50-280

INFORMATION CONCERNING HIGH DENSITY SPENT FUEL
STORAGE RACKS....INS RESPONSE TO NRC QUESTIONS
SUBMITTED BY LTR DTD 8/25/77.....

FINITE ELEMENT MODEL NODE NUMBERING
FIGURE 8-1

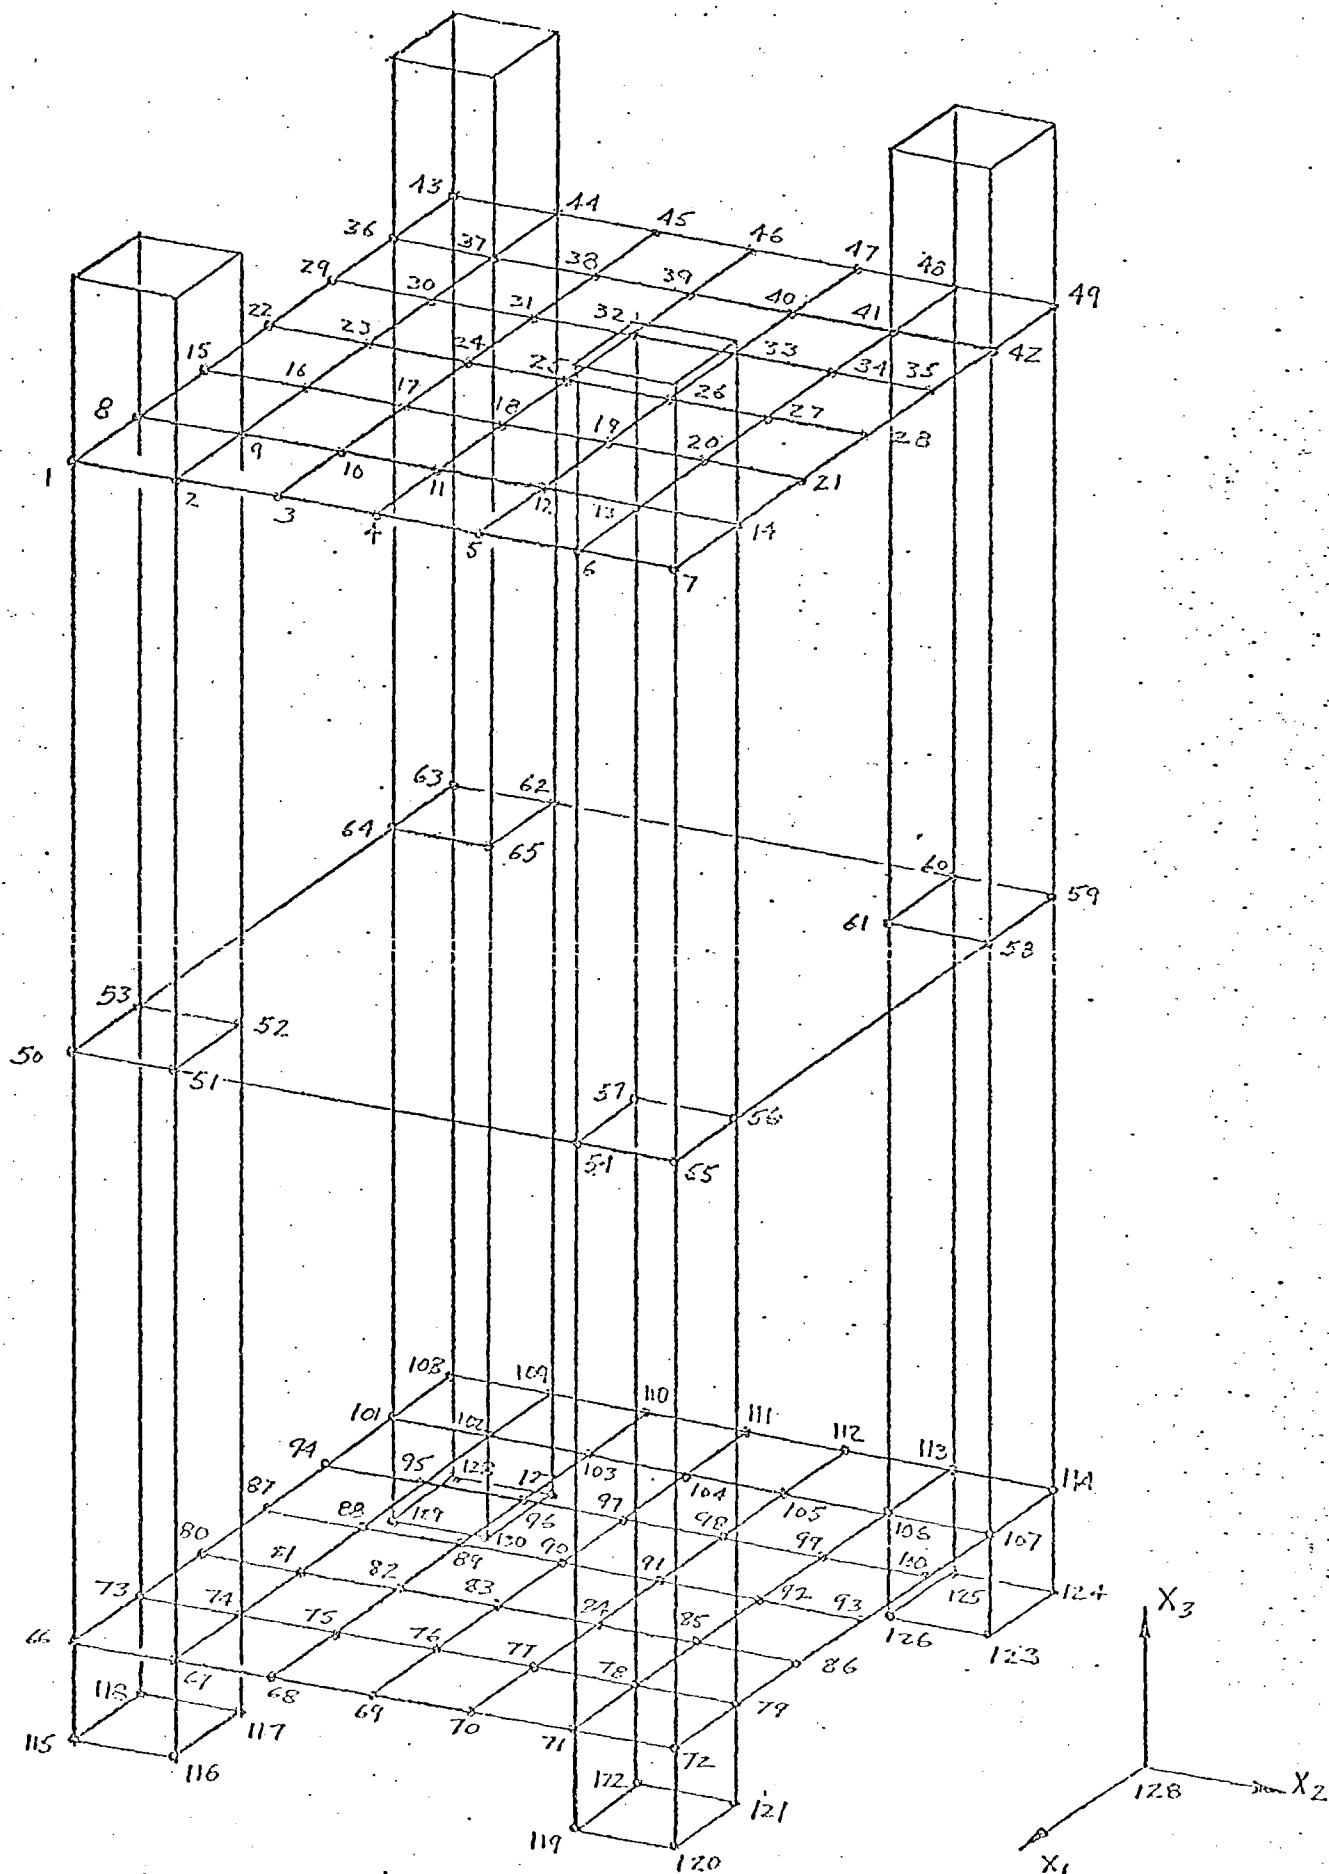
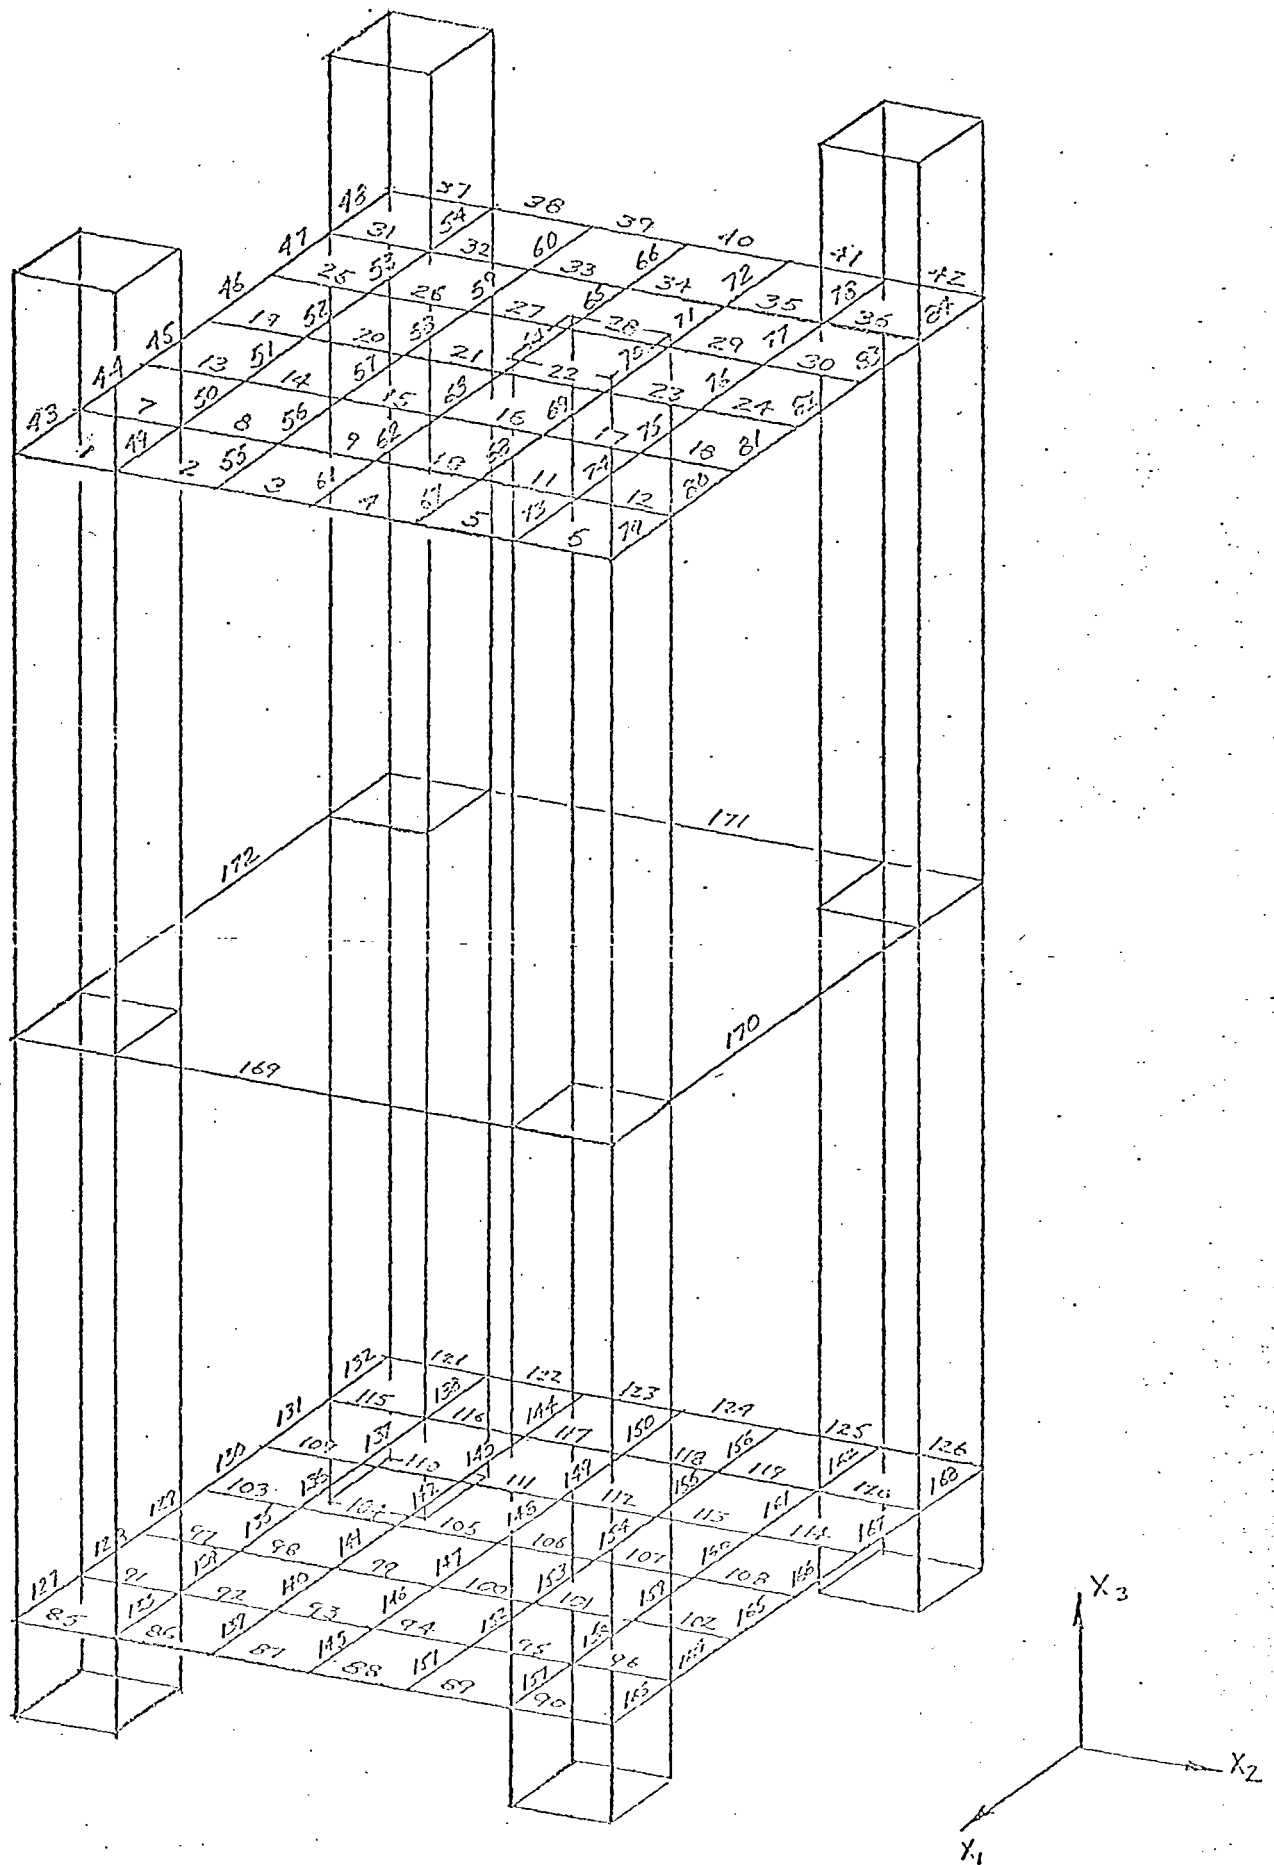
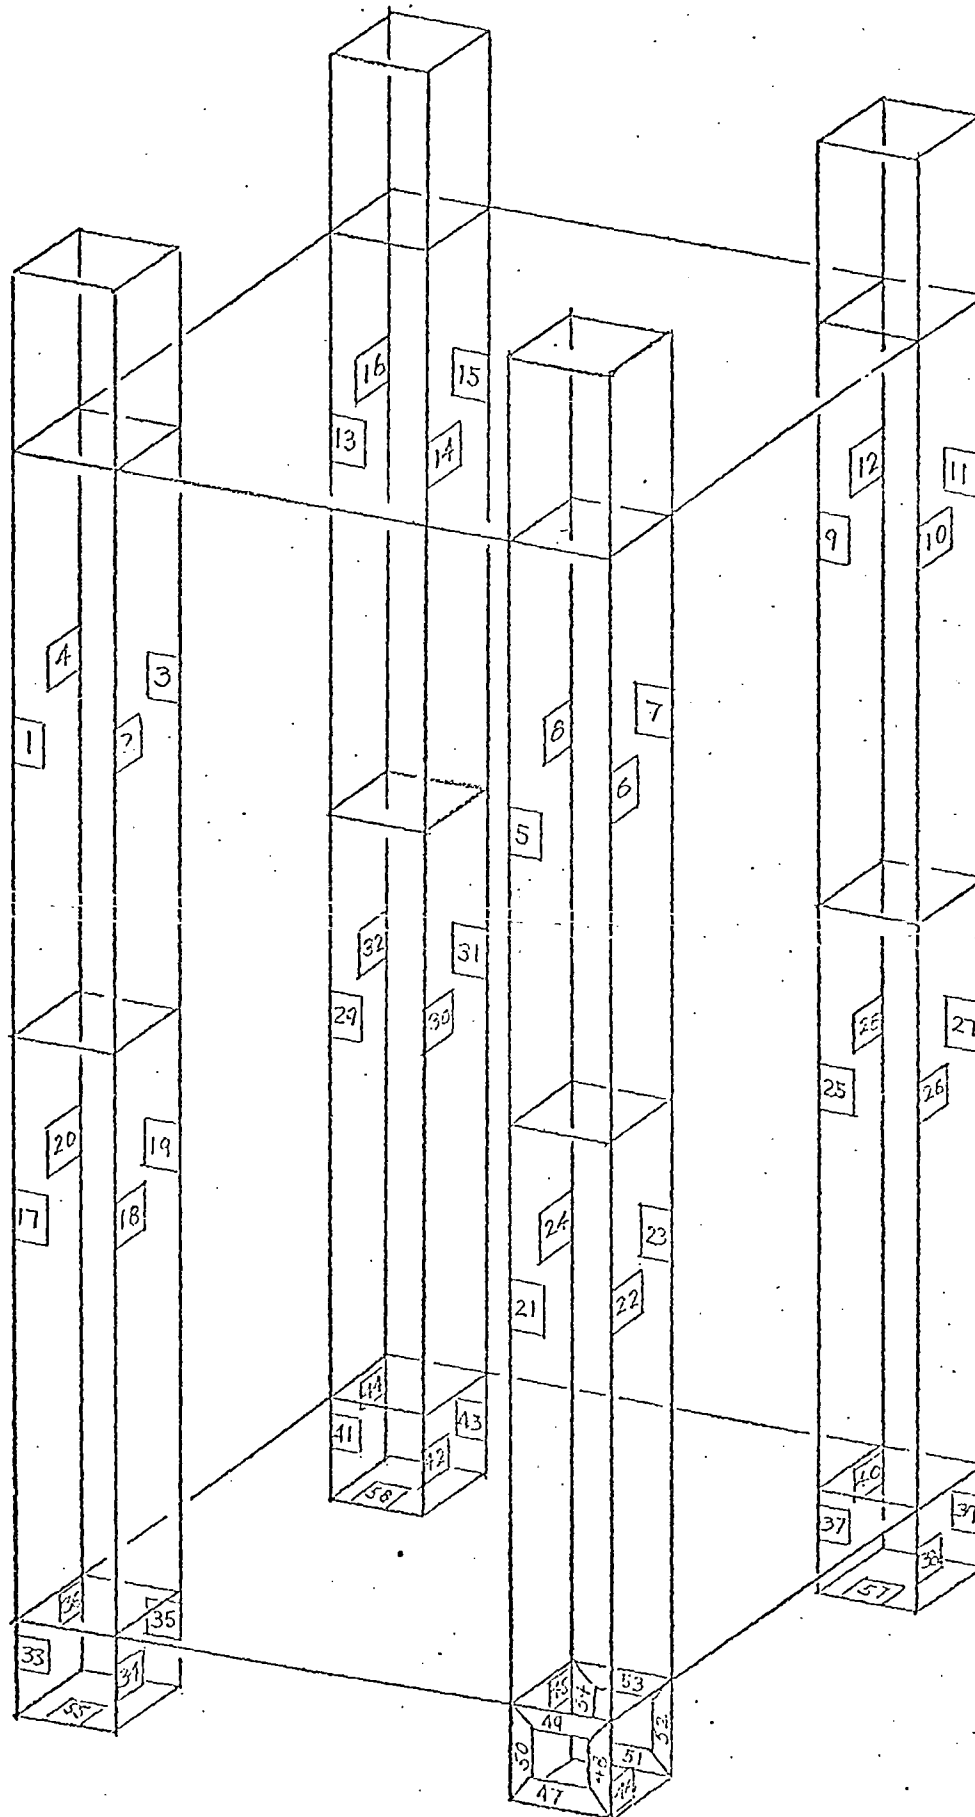
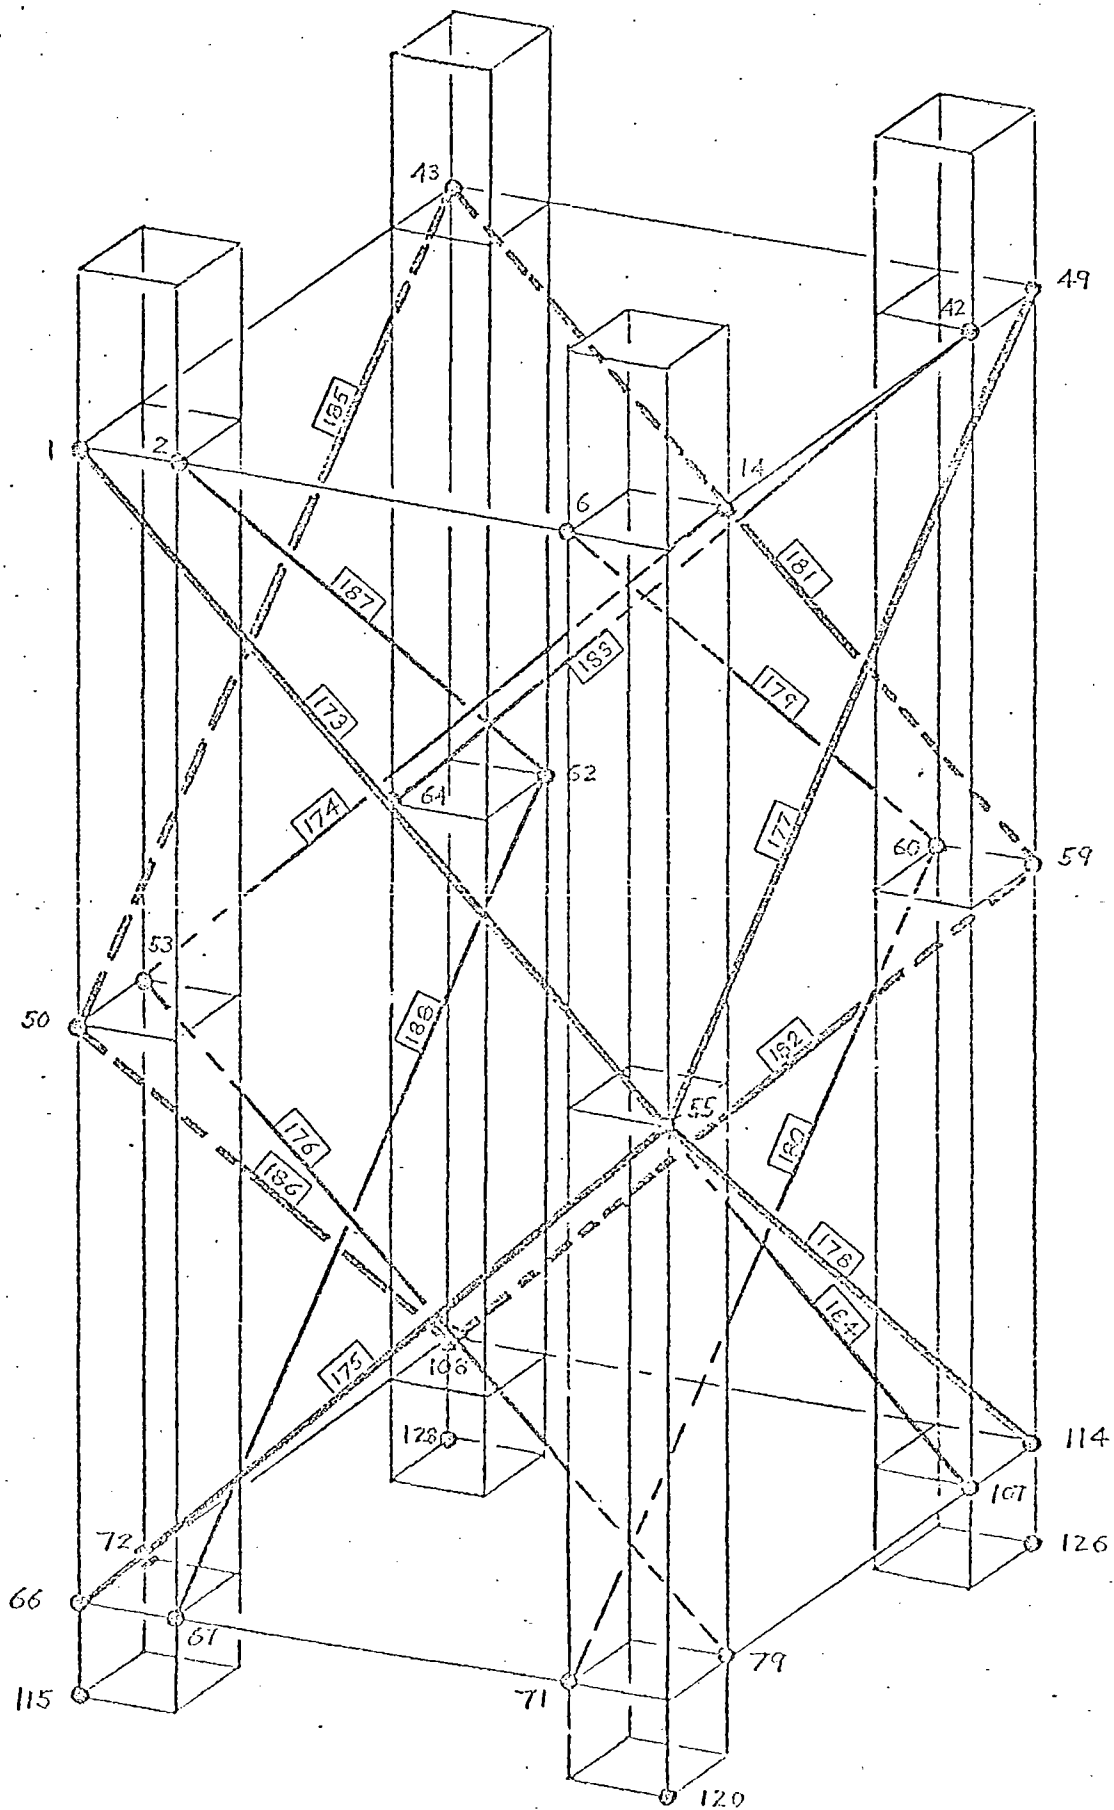
Question 8: Provide a description of the dynamic model of the rack, fuel pool system clearly showing the boundary conditions. Also indicate the damping values used in your analysis. Since the proposed rack system is inherently weak in torsion discuss what considerations were given to obtain the highest torsional effects due to possible non-uniform mass distribution.

Response: For the dynamic analysis, the fuel storage rack structure has been mathematically modeled as a three dimensional finite element structure consisting of discrete three dimensional elastic beam and plate elements interconnected at a finite number of model points as shown in Figures 8.1 through 8.4. Figures 8.5 and 8.6 show the model boundary conditions and the lumped mass distribution used in the seismic analysis of the fully loaded and partially loaded fuel storage racks respectively. The damping values used in the seismic analysis of the high density fuel storage racks are four percent for the Operating Basis Earthquake (OBE) and six percent for the Safe Shutdown Earthquake (SSE). The NRC Regulatory Guide 1.61 permits damping values of two percent for OBE and four percent for SSE for welded steel structures functioning in air. These damping values are increased by two percent since the fuel storage racks are welded stainless steel structures completely submerged in water. This two percent increase in damping value for submerged structures is based on Section 6.4 of "Fundamentals of Earthquake Engineering" by N. M. Newmark, and E. Rosenblueth.

The fuel storage rack (six by six array of fuel storage cells) consists of upper and lower grid structures connected to each other by means of four corner cells and the diagonal bracing members. The fuel storage rack thus structurally becomes equivalent to a box shaped structure which is inherently strong in torsion. The torsional effects due to possible non-uniform mass distribution are considered in the analysis by analyzing the partially loaded rack. (Figure 8-6).
